PERMIT

SEWAGE DISPOSAL SYSTEM
HOWARD COUNTY HEALTH DEPARTMENT
BUREAU OF ENVIRONMENTAL HEALTH
410-313-2640

P 515002
A 45331
ISSUE DATE 3/26/2001
APPROVAL DATE 5/4/01

UBDIVISION Stout Property LOT NUMBER .1 ADDRESS 15814 Old Frederick Road

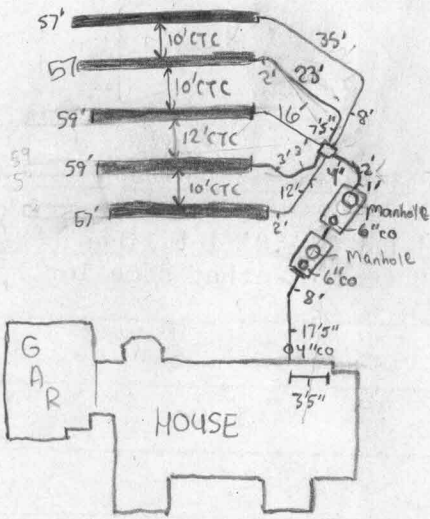
PRE-CONSTRUCTION INSPECTION: 5/1/01 Unable to use upper part of easement with a gravity system. To install another tank for future pumping. To

INSPECTION COMMENTS: run 5 - 50' to 60' trenches near second septic tank and run them toward left lot line. 7' edge to edge spacing. (B&B)

5/2/01 - OK TO INSTALL A 1250 GALLON ST IN FRONT OF 1500 GALLON PUMP TANK, PLACE BAFFLES IN PUMP TANK BOTH ON INLET & OUTLET W/16" EXT., CHANGE PIPE OUT OF PT TO BE 2-45'S INSTEAD OF A 90 BEND, KEEP DIRT OUT OF STONE! (SRK)

5/3/01 P.M. OK TO COVER FIRST FOUR TRENCHES. 2nd tank not set. DIC

5/4/01 - OK TO COVER ALL WORK (SRK)
